Owner Occupied and Scattered Site Rehabilitation Programs

Addendum # 2 September 15th, 2017

Project # 2203 Property Address: 700 East Broadway, Milford, CT

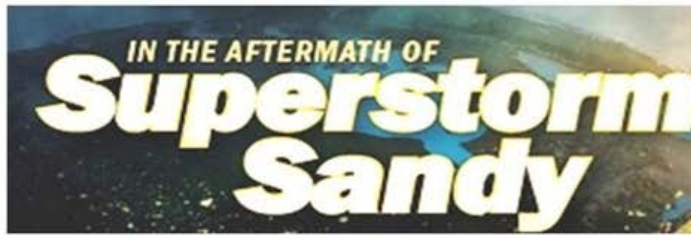
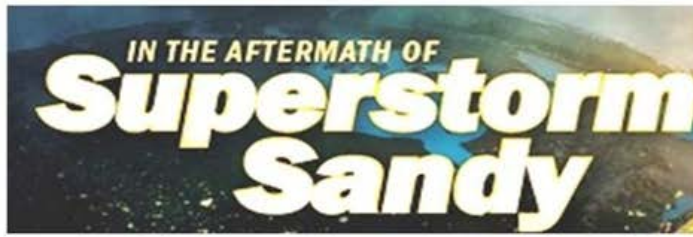
Drawing S4 specifies a pile design that is 3 1/2" O.D. diameter with 0.300" wall thickness filled with grout. The bid document 'Section 31 66 15 – 2.1 Materials' does not call for a specific pile design. They do mention that the wall thickness should be a minimum 0.262 inches. I have two pile designs that work, including the 3 1/2" O.D. diameter noted on drawing S4. There is a cheaper, smaller diameter option that satisfies the load requirements though. Also, in both pile designs, the use of grout is unnecessary according to the manufacturer's software. What are your thoughts?

Note the specifications and drawings require the submission of a helical pile design calculations demonstrating the installation shall develop a minimum allowable load capacity of 10 tons (20 kips) per drawing S-1. Refer to bid specification Section 00 31 32 "Existing Geotechnical Data" for soil boring data provided for use in contractor design.

Product substitutions shall be considered on an 'approved equal' basis per specification. Contractor shall prepare bid for helical pile installation using 3-1/2" O.D. Round shaft helical piles with minimum wall thickness of .300 inches. Helix plate configuration per contractor design.

Piles are required to be filled solid with grout per drawing S-1.
